Addendum No. 2 - Bid No. 25-41

April 9, 2025

Fresno High School Cafeteria and Site Improvements 1839 N Echo Ave Fresno, CA 93704 DSA App No.: 02-120778

C-302

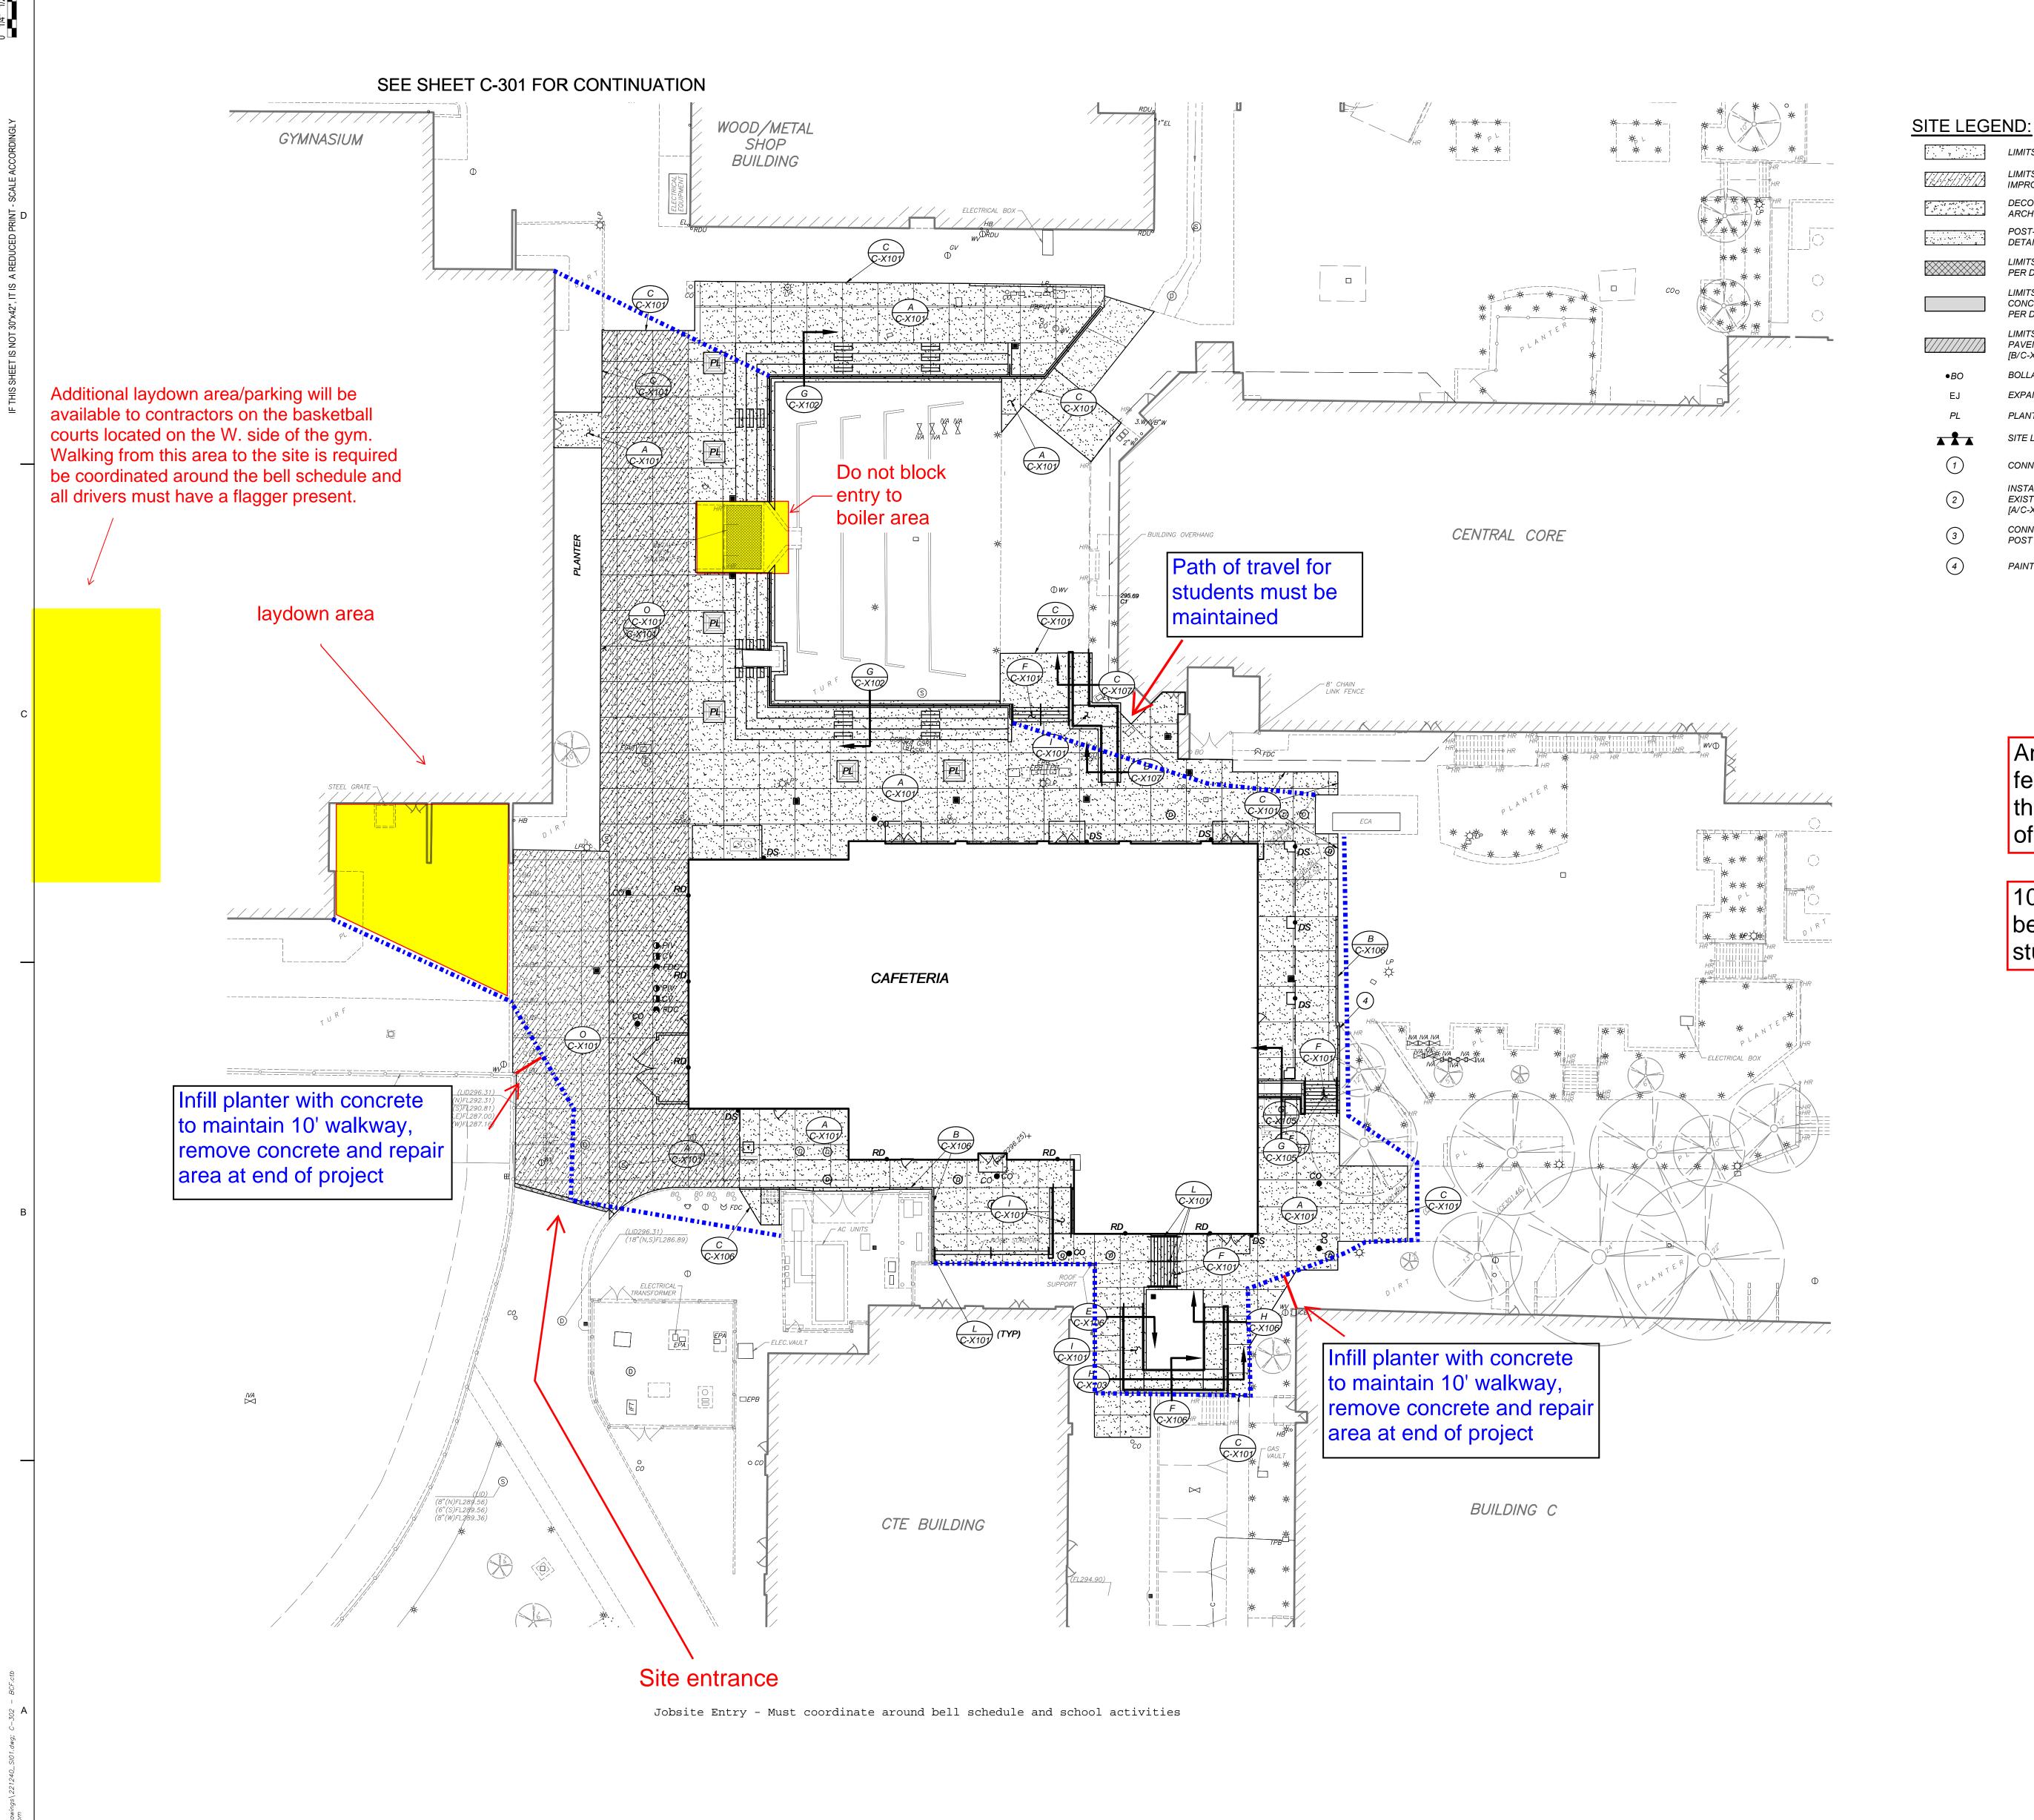
1. Add attached C-302 with additional site and fencing requirements.

Any areas outside of the outlined fenced area must be coordinated with the owner prior to performing scope of work.

10' walkway and ADA compliance is to be maintained around all fencing for student path of travel
